**PRODUCT NOTICE #160119:  
DIGI XLR PRO UPDATES – F/W 1X07, BOM UPDATE, MEXICO CERTIFICATION**

**Product:** Digi XLR PRO Industrial Radios

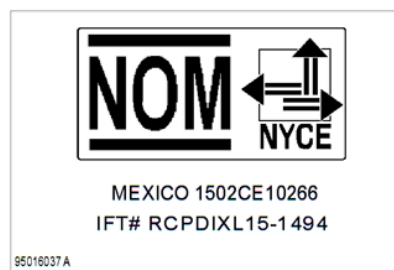
- Mini-USB port now available for configuration
- Added ping command – 'ATPG'
- Firmware updates through the WebUI now auto-filter
